PLANNING AND ZONING BOARD STAFF REPORT

The Maxwell

Meeting	File No.	Application Type
June 16, 2025	2023-196-SPF-SPR-LV4	Level 4 Site Plan with waiver
Property Owner	Applicant	Authorized Agent
306 NE 2 nd Street LLC	Harold Van Arnem	Jon Kinsman

Provide a recommendation to the City Commission on a Level 4 Site Plan application for a four-story, 45,247 square-foot mixed-use building at 306 NE 2nd Street, known as *The Maxwell*, including Architectural Elevations; a Landscape Plan, with an associated landscape waiver to the required five-foot perimeter landscape strip; and a determination of adequacy for reduction of required off-street loading.

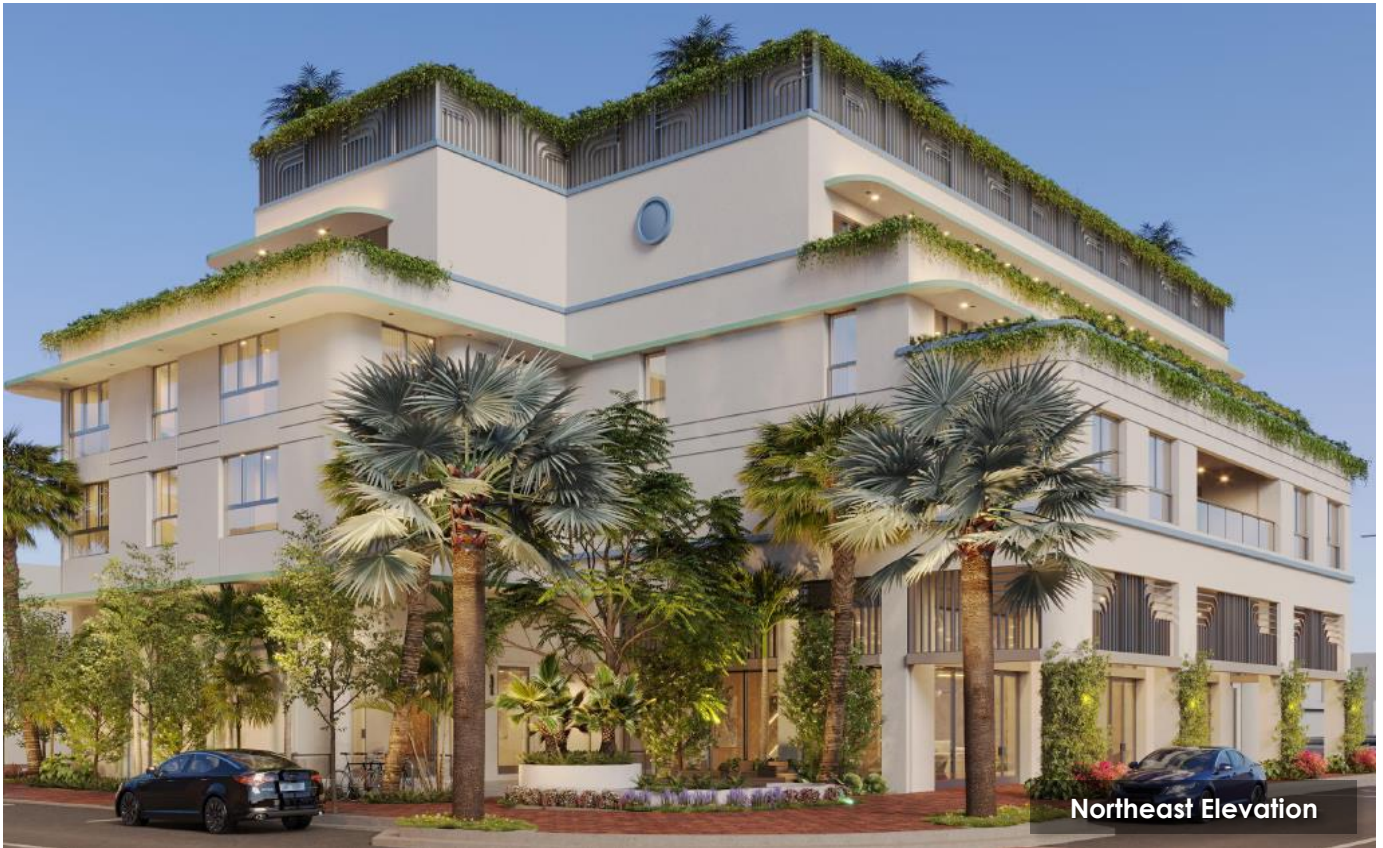
The design authentically captures the essence and visual impact of the Art Deco architectural style. The surrounding area consists of primarily Masonry Modern design. The design keeps with the modern aesthetic shown in the surrounding area, yet steps away from the masonry modern style and attempts a streamline Art Deco style, a style that is consistent with the permitted architectural styles outlined in the *Delray Beach Central Business District Architectural Design Guidelines*.

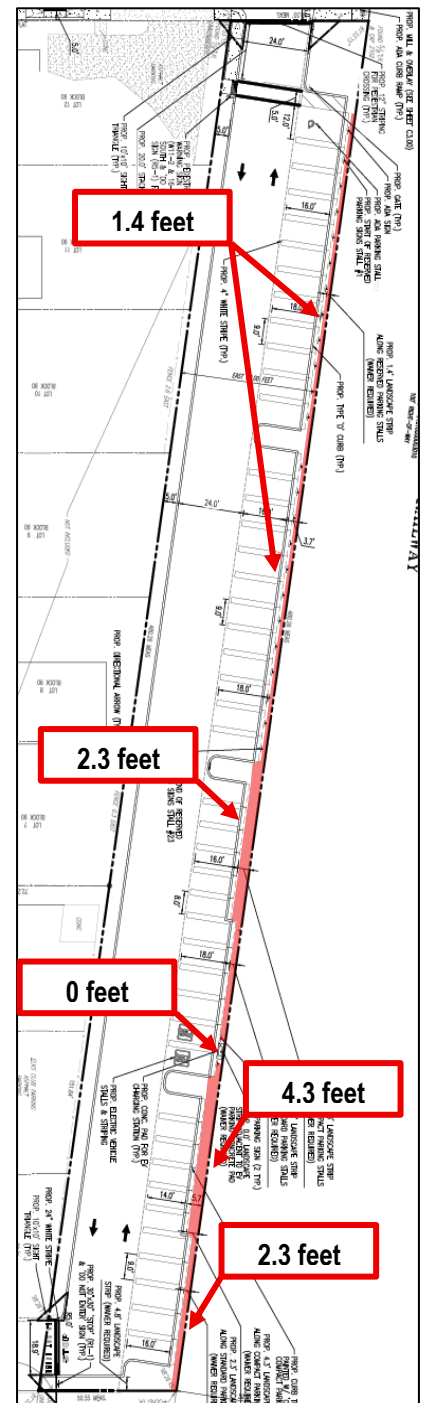
The current parking layout spans 480.26 feet long by 50 feet wide that allows vehicles to access the lot from NE 2nd Street and exit northward. Given the site's limited width, compliance with both the standard parking layout and the required 5-foot landscape buffer is not feasible without reducing parking capacity or reconfiguring circulation.

Additionally, a required 2-foot overhang cannot be included within the required 5-foot landscape buffer. The proposal also includes signage marking the residential reserved spaces and an EV concrete pad; the area where the signage and EV concrete pad is located cannot be included in the 5-foot landscape buffer. As a result, the proposed buffer varies in depth:

- **0 feet** where the EV pad is located.
- **1.4 feet** along the area with signage.
- **2.3 feet** in the remaining sections to the north.
- **4.3 feet** along a portion of the compact spaces

While the full 5-foot width is not maintained, the applicant proposes continuous landscaping within the reduced-width buffer areas. The landscape plan includes the required plant materials to the extent feasible, and efforts have been made to preserve visual screening along the right-of-way through enhanced planting design within constrained areas. The variation in buffer depth has been designed to minimize visual disruption and maintain an aesthetically cohesive frontage.
